Subject: UniStar Nuclear Energy, NRC Docket No. 52-016
Response to Request for Additional Information for the
Calvert Cliffs Nuclear Power Plant, Unit 3,
RAI No. 71, Basic Geologic and Seismic Information
RAI No. 72, Vibratory Ground Motion

**Response Summary for Request for Additional Information,
RAI No. 71, Basic Geologic and Seismic Information,
and RAI No. 72, Vibratory Ground Motion
Calvert Cliffs Nuclear Power Plant Unit 3**

**Partial Response to NRC Request for Additional Information,
RAI No. 71, Basic Geologic and Seismic Information,
and RAI No. 72, Vibratory Ground Motion
Calvert Cliffs Nuclear Power Plant Unit 3**

Figure 1. Approximate altitude of the top of the Piney Point-Nanjemoy aquifer showing cross section locations A - A' and B - B' (modified from Achmad and Hansen, 1997).

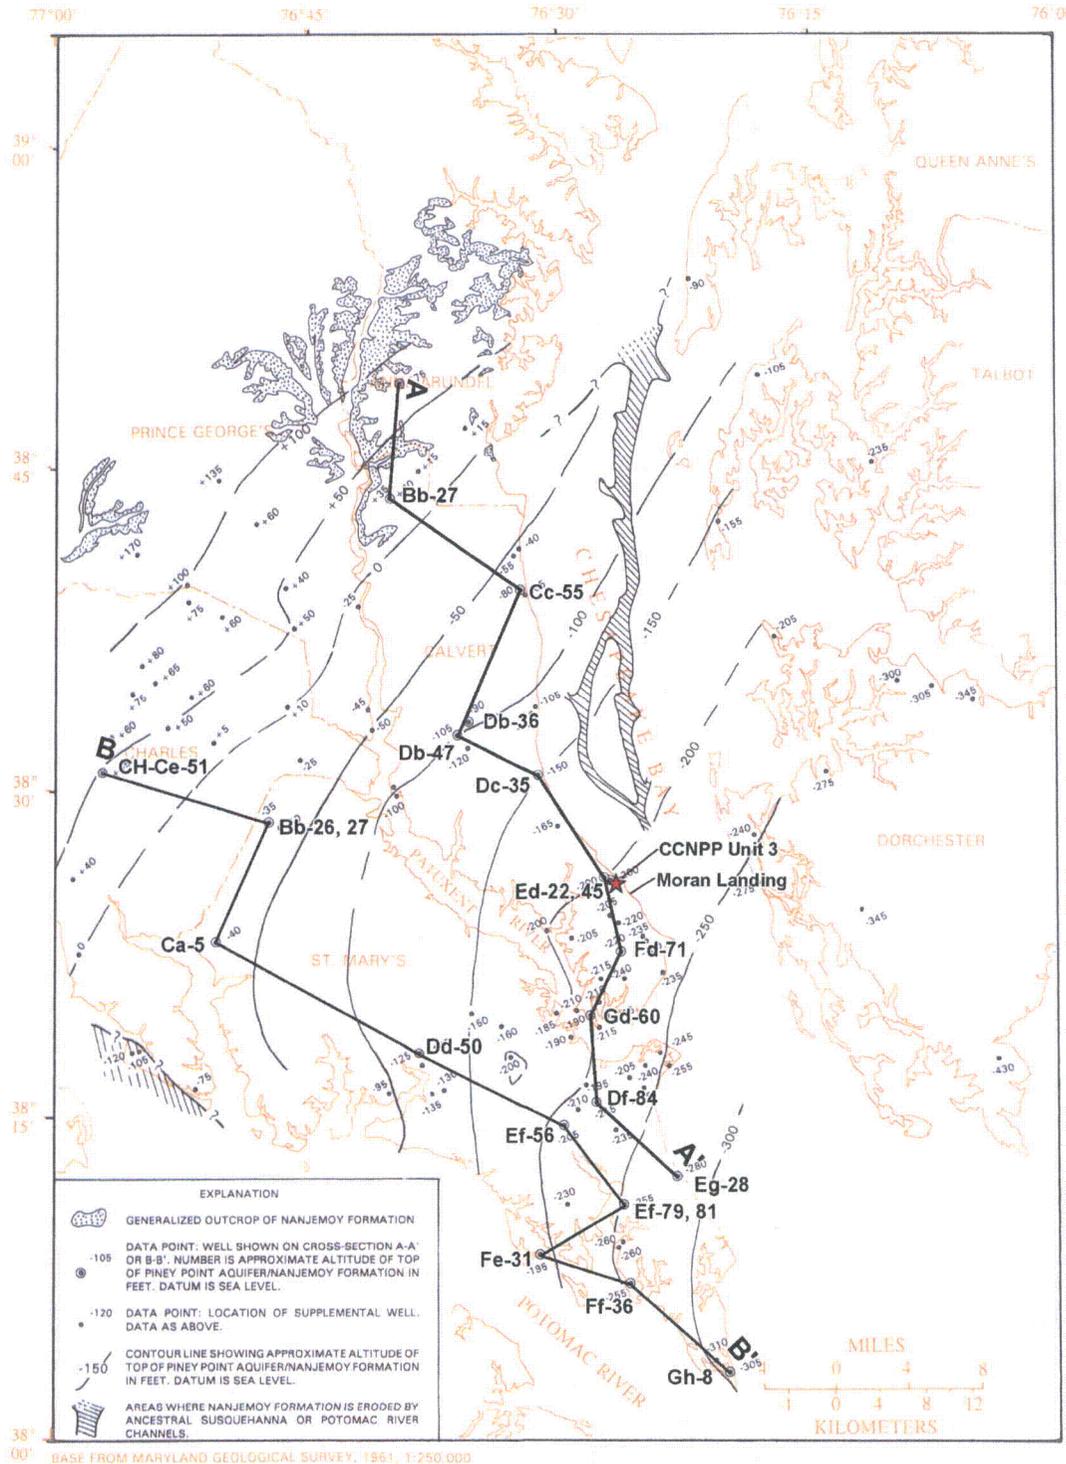
FSAR Section 2.5.1.1.4.1.2 states "Northwest-southeast-directed postrift shortening, manifested in Mesozoic basin inversion structures, provides the clearest indication of this change in stress regime (Withjack, 1998)." On FSAR Figure 2.5-13 there is a shallow structural high at borehole CA Gd 60 (Solomons) that dies out with depth that is consistent with typical inverted grabens. Furthermore, the fault proposed by Kidwell (1997) referred to in FSAR Section 2.5.1.1.4.4.4.8 appears to coincide with this high.

The apparent "shallow structural high" referenced in this question is best explained as a result of a change in orientation of the cross-section line of Achmad and Hansen (1997) with respect to the regional dip of the Coastal Plain sediments and not as an inverted Mesozoic fault. Included with this response are three figures (copies attached and enlarged prints are included in Enclosure 3). Figure 1 depicts the location of the boreholes used to develop cross-sections A-A' (Figure 2) and B-B' (Figure 3) of Achmad and Hansen (1997). Note that Figure 2 is a modified version (color for three geologic formations, labeling of 'Moran Landing', and an added description of the orientation of the cross section with respect to the regional dip of the Chesapeake group) of FSAR Figure 2.5-13 and is presented for this response only. The geologic cross-sections intersect the southeast projection of the hypothesized Kidwell fault and the apparent "shallow structural high" referred to in this question. These regional geologic cross-sections demonstrate that neither the hypothesized Kidwell fault nor the hypothetical inverted Mesozoic fault are apparent in the Chesapeake Group stratigraphy. Both scenarios are discussed below in additional detail.

In summary, when the inferred "shallow structural highs" are placed in context with the orientation of the geologic section with respect to bedding strike and dip, the anomalous features can be readily explained by the trend of the cross section line. This explanation is more plausible than a previously unidentified inverted Mesozoic fault.

Figure 02.05.02-9A. Deaggregation of 10 Hz spectral acceleration at 10^{-4} for the Rondout team.

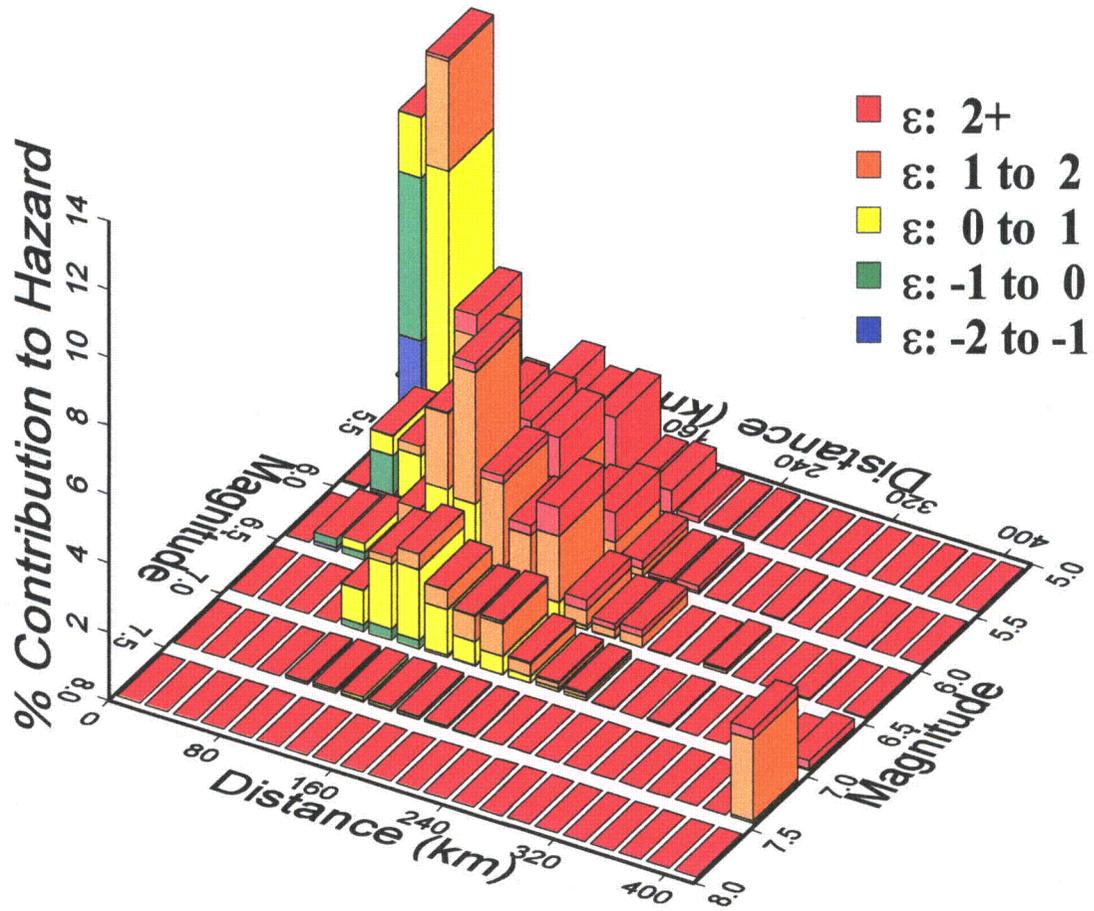
(a) Using the procedure specified in Appendix D to RG 1.208, the applicant obtained values of $M=5.5$ and $R=97$, which fit well with a source in the CVSZ. Given that FSAR Figure 2.5-91 shows the CVSZ clearly controls high frequency motions, please justify the use of the alternative method.

a) CCNPP Unit 3 FSAR Figure 2.5-91 shows the hazard curves for 10 Hz spectral acceleration by source for the Rondout Earth Science Team (team). For this team and this spectral frequency, the Central Virginia seismic zone (CVSZ) dominates the hazard. This is also evident in Figure 02.05.02-9A, (see below) which is a deaggregation of 10 Hz seismic hazard for the Rondout team only, calculated at a 10 Hz amplitude of 0.15 g (which is the 10^{-4} spectral amplitude for 10 Hz for all teams). The contribution to seismic hazard in Figure 02.05.02-9A from about 80 to 160 km shows the importance of the CVSZ for the Rondout team.

Figure 02.05.02-9B. Deaggregation of 10 Hz spectral acceleration at 10^{-4} for the Rondout team.

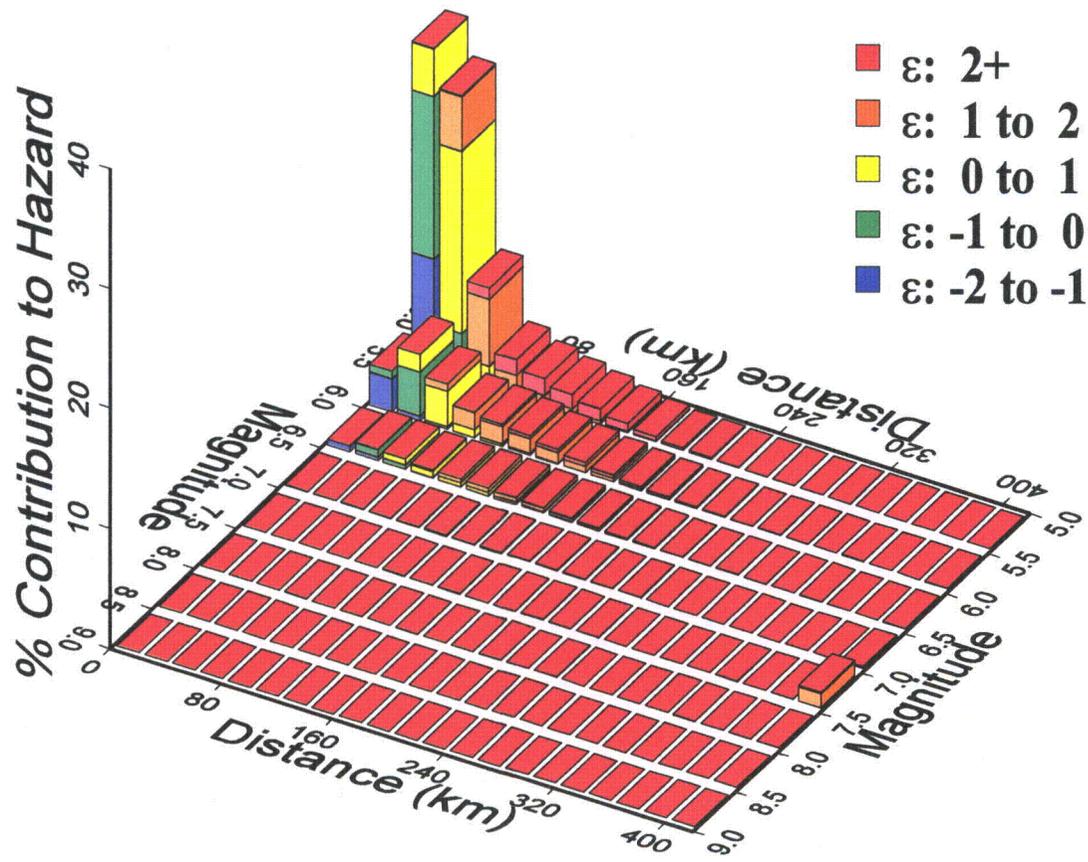
(c) Which source zone (from which team) actually dominates the large contribution to the hazard at $M 5.0-5.5$ and $R 10-20\text{km}$ shown in FSAR Figure 2.5-67? Please provide a figure like FSAR Figure 2.5-91, which shows the relative contribution to the hazard of the sources from that team.

For comparison, Figure 02.05.02-9B (see below) shows a similar 10 Hz deaggregation for the Bechtel team. For this team the contribution of the CVSZ to 10 Hz hazard is much less important, and the host source (which for the Bechtel team is BZ5) is dominant. This source has an important contribution from 0 to 40 km.
